| NO: REL - 196 | PRODUCT: G8N and G8NW – Micro-mini PCB Automotive Relay |
| DATE: December 2017 | TYPE: Modification – Country Of Origin Change |

G8N and G8NW Micro-mini PCB Automotive Relay Country Of Origin Change

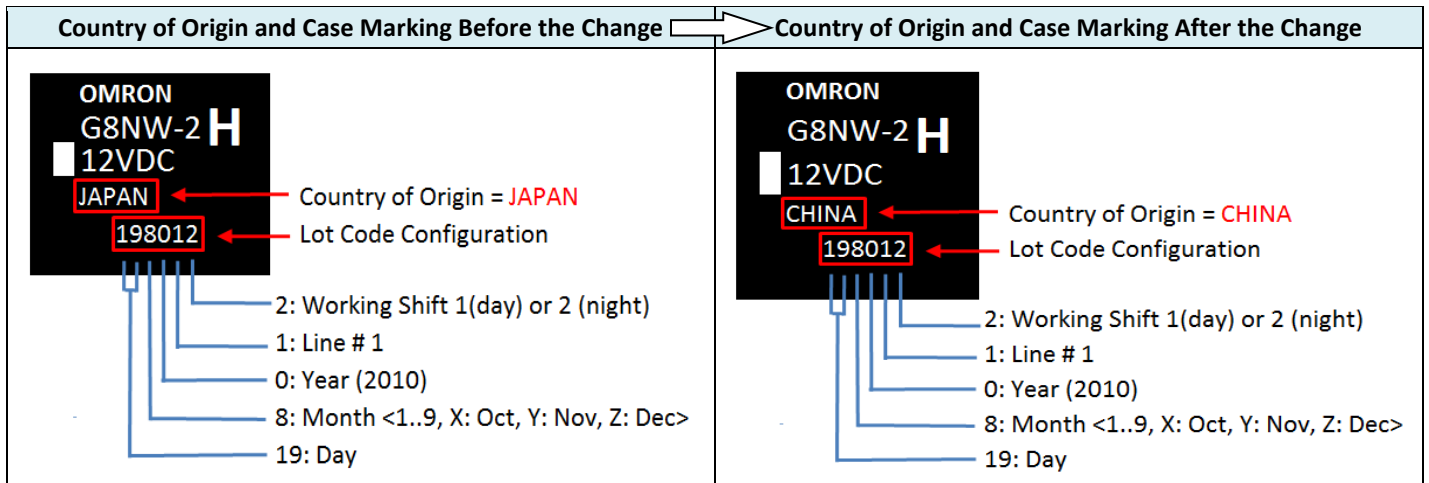
G8N Details of the Changes:

G8NW Details of the Changes:
